**Coal Combustion Waste Impoundment  
Round 5 - Dam Assessment Report**

*Greene County Steam Plant (Site 013)*

*Fly Ash Dike*  
*Alabama Power Company*  
**Greene County, Alabama**

Dewberry & Davis, LLC  
Fairfax, Virginia

**Photo 2: Typical View of Canal Erosion, #2**

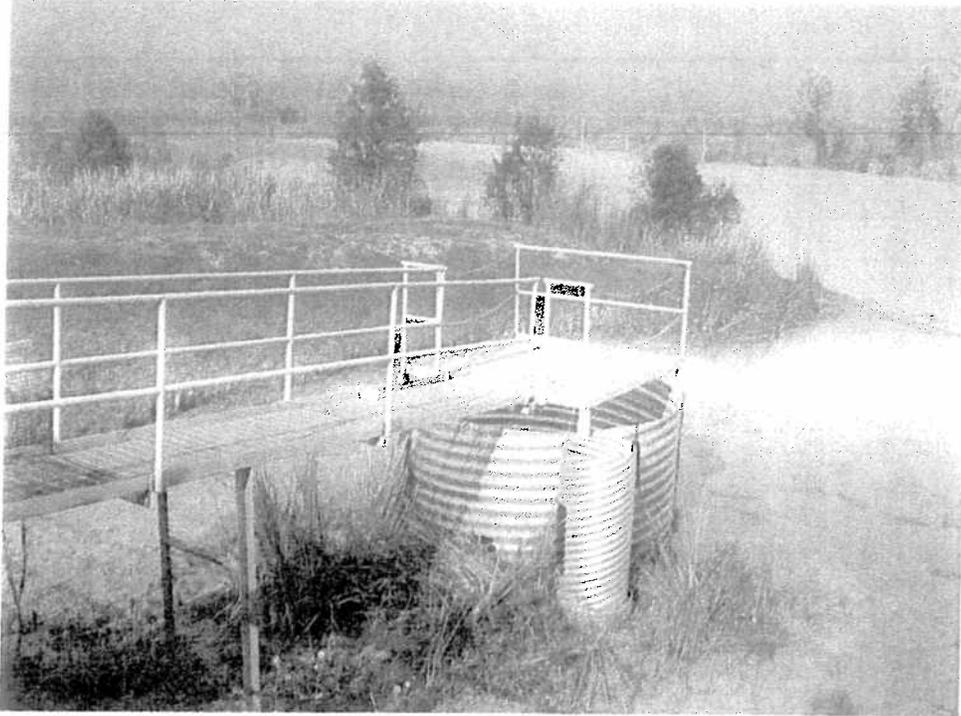
<b>No.</b>	<b>Description</b>	<b>Location</b>
1	It is suggested that the plant consider armoring the narrow, extended sloughs along the east dike. This could be done with riprap and could slow the sloughs' advancement.	East Dike (see Photo 2)
2	It is recommended that any areas damaged by equipment traffic be repaired.	All Embankments, but specifically the South Dike (see Photo 6)
3	It is recommended that the oversteepened area on the South Dike be flattened to match the remainder of the embankment.	South Dike
4	To the extent feasible, it is recommended that trees encroaching on the dam toe be cut back from the embankment.	South Dike (see Photo 7)
5	It is recommended that the flanks of the crest be gradually flattened (by a road-grader, bulldozer, etc.) so that it more closely matches the slope of the embankment.	All Embankments, but especially along the South Dike (see Photo 8)
6	It is recommended that the area along the toe of the west dike be cleared 5-7 feet to the extent possible without encroaching on the adjacent wetland.	West Dike

**Photo IN-15: Small Seeps on Downstream Toe, North Dike**

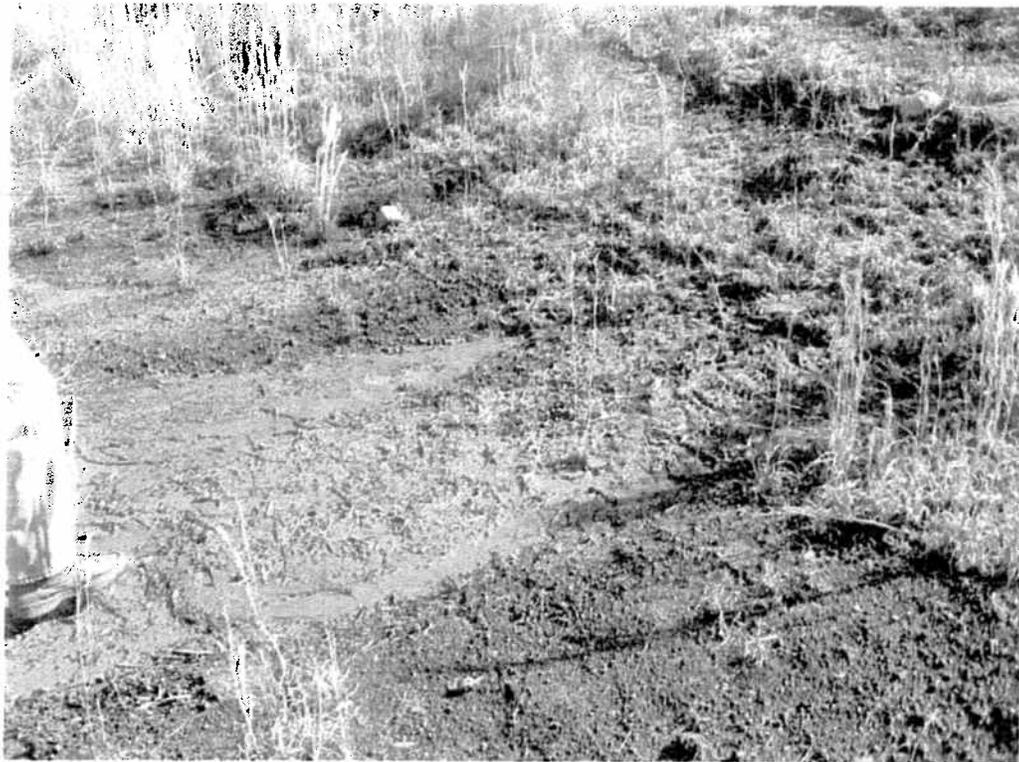
7	It is recommended that the plant staff, during their regular inspections, pay close attention to any wet areas or areas of known seepage.	All Embankments, but especially the West Dike and North Dike (see Photos 15 and 17)
